Minutes
Farmington High School Building Committee
Financial Subcommittee
ZOOM
Friday, January 13, 2023
8:30 A.M.

Proposed Change Order

Project: Farmington High School and Central Office Projects

Change Name: Phase 1 Credits and Adds

C2.0

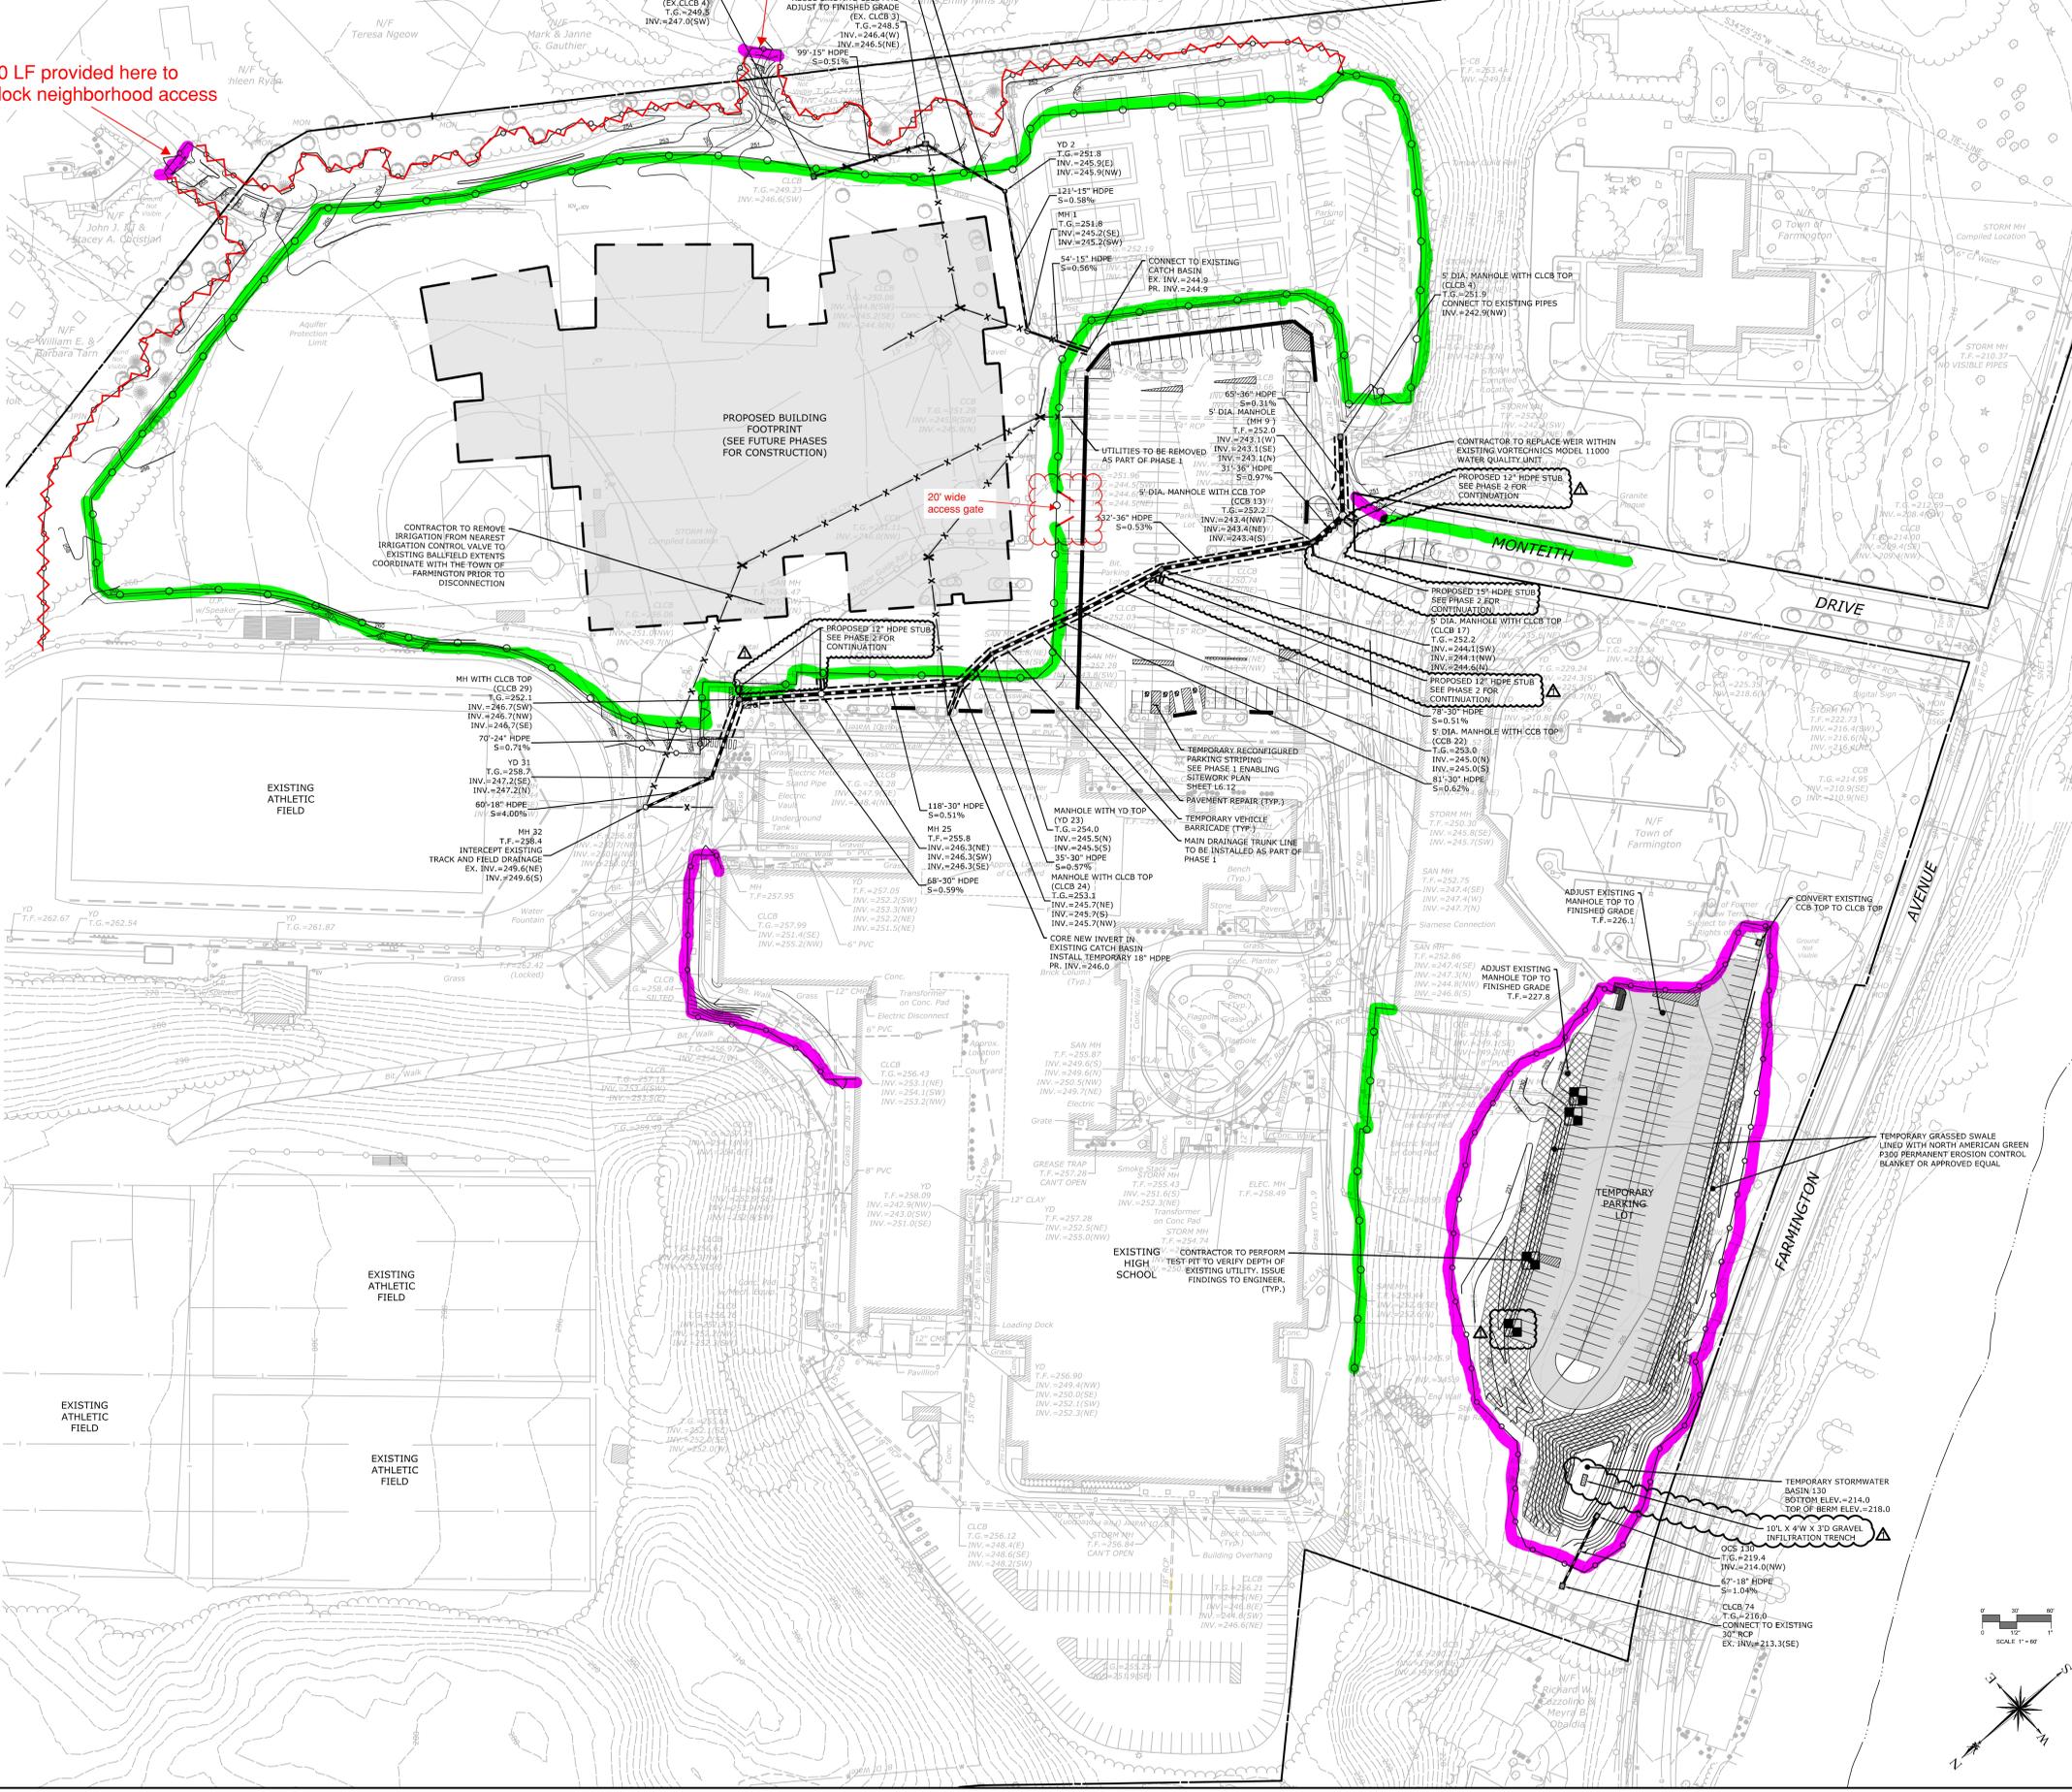
Revisions to temporary fencing per attached marked-up Drawing C2.0: Deduct <\$145,265.50>
Reduce thickness of processed base payer under temporary parking lot from 8" to 4": Deduct <\$20,000.00>

- = 6' high portable chain link fencing with weighted bases and no scrim fabric
- = 8' high chain link fencing with driven posts and scrim fabric, 2" line and 2.5" terminal posts, top rail, bottom wire to be 11.5 gauge
- = Temporary fencing proposed to be eliminated

30 LF provided here to block neighborhood access

30 LF provided here to block neighborhood access

20' wide access gate
